Reference: Response to Information Requested December 6, 2018

On behalf of Weaver Wind LLC (Weaver), please see the enclosed for additional information requested by the Land Use Planning Commission (LUPC) in its review of the Request for Certification for the Weaver Wind Project.

WEAVER WIND PROJECT WEAVER WIND, LLC

Revised Figure 31-3 (Comment 8)

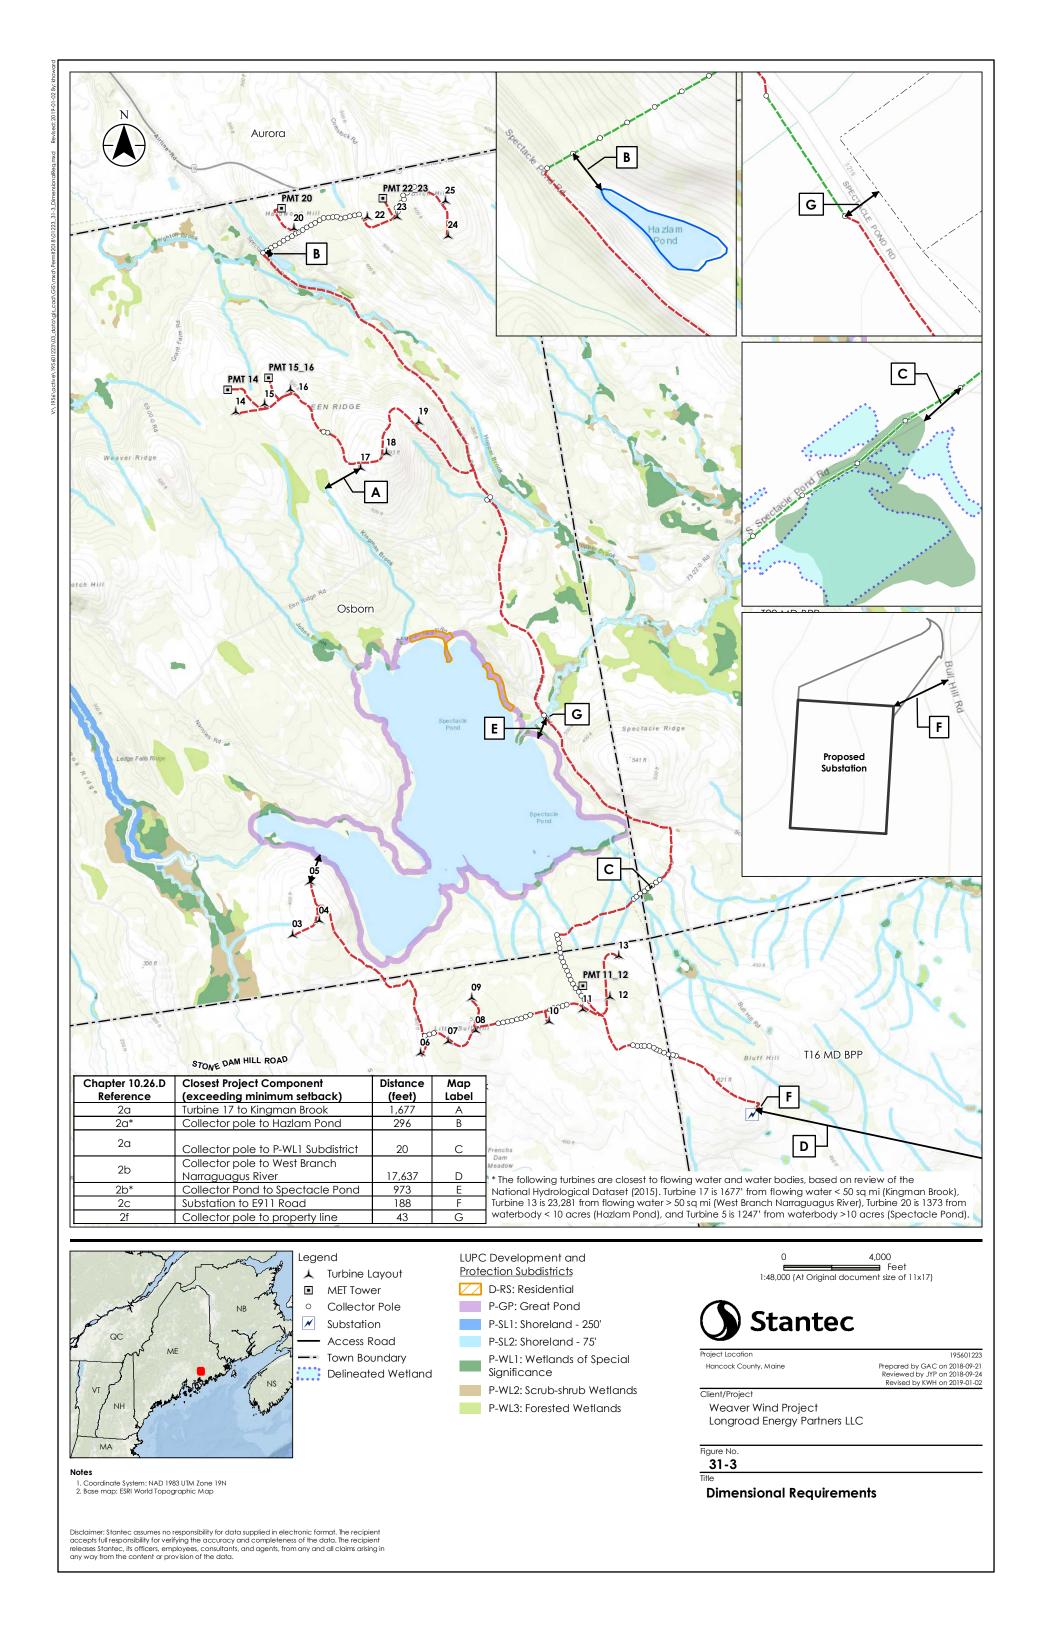
- 8. Please show the Stone Dam Road, turbine numbers, and permanent met tower numbers on Figure 31-3 to aid in the LUPC review of road setbacks. Also, on Figure 31-3;
 - a. Indicate the closest distance from a turbine to a body of standing water greater than 10 acres in size, showing the location and the distance. Based on the figure, it appears the closest turbine may be Turbine #5.
 - b. Is Turbine #17 the closest turbine to a river, stream, or brook? It looks like other turbines, such as Turbine #3, may be closer to streams.
 - c. Have the structure setbacks to streams been verified based by field data?
 - d. In the Figure 31-3 table, the reference for map label F indicates a met tower to road setback, shouldn't this read substation to road?

Weaver Response: Figure 31-3 has been revised (Exhibit A) to show Stone Dam Road, turbine numbers, and permanent met tower numbers. In addition, for a) a note has been added to indicate the closest turbine to water bodies and flowing water. Our review was based on the National Hydrological Dataset, specifically the flowpath dataset which is current as of 2015 and includes mapped features from 2011-2015. For b), we recognize that LUPC has a mapped P-SL2 district in the vicinity of Turbine 3; however, no stream was

identified within our delineation limits of 500' from this turbine. For c), no streams were delineated within 500' of any turbine. Any streams beyond 500' were not field verified. For d) the table has been revised to reflect the correct setback.

Intersection Details (Comment 14)

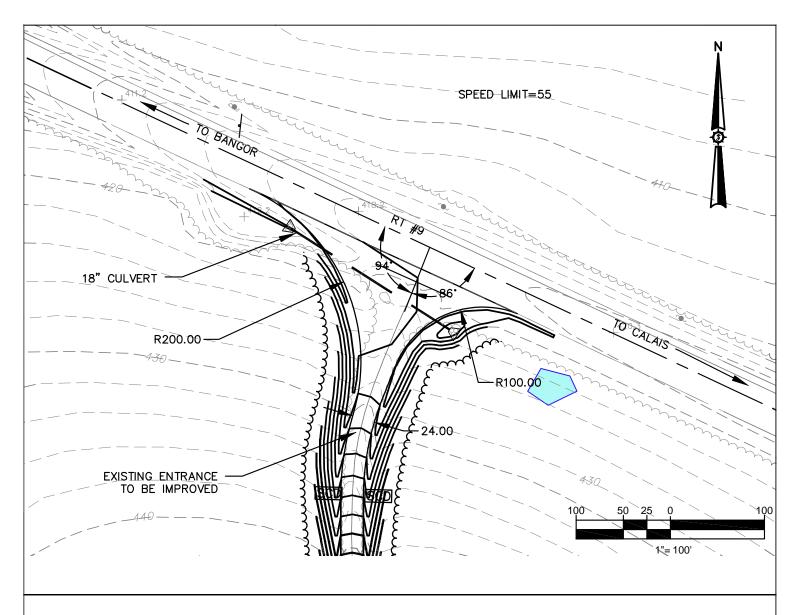
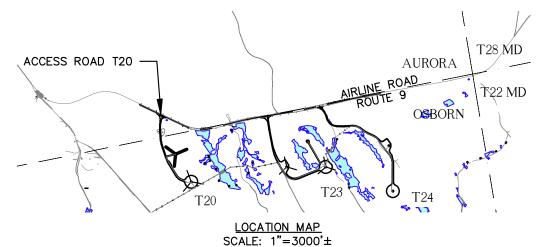
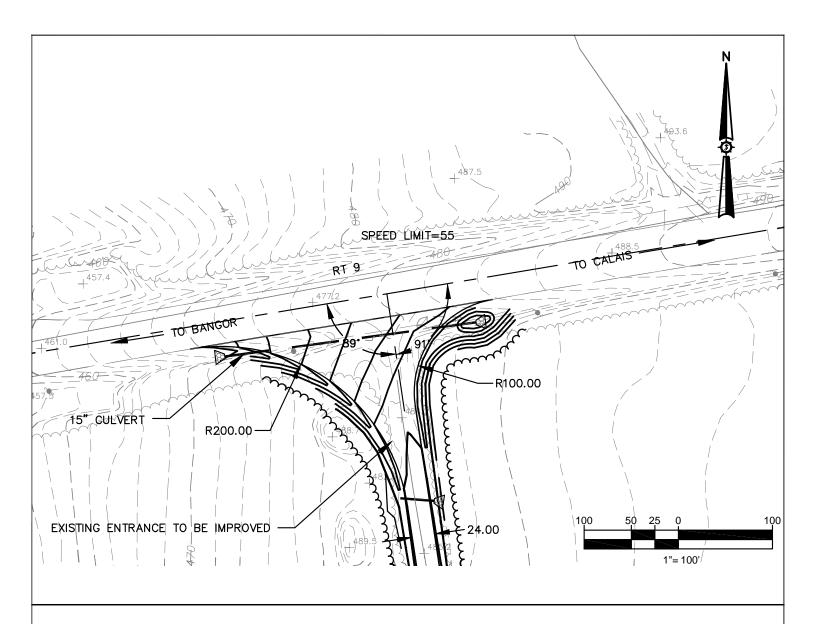
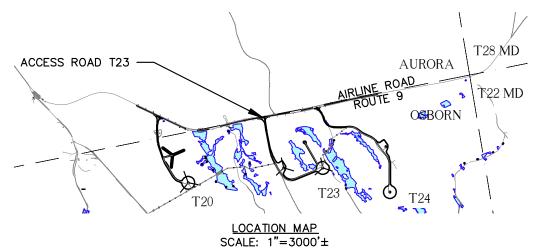
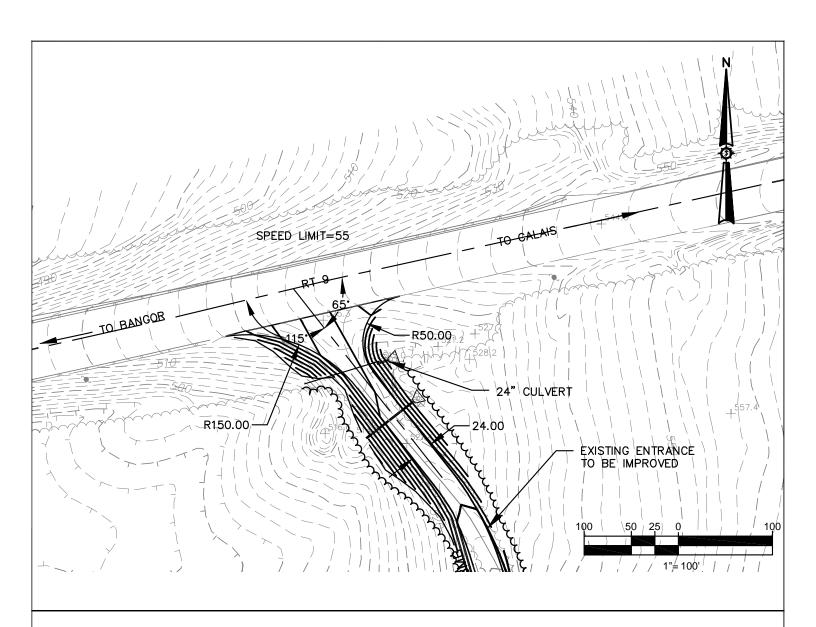
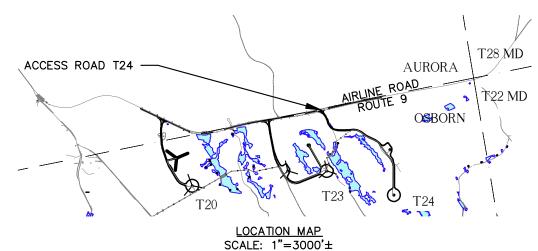
14. Describe all new and improved intersections proposed for the project and provide detailed information on angles and curb radii.

Weaver Response: Detailed information on angles and curb radii for the intersections proposed for the project in LUPC jurisdiction are provided in Exhibit B.
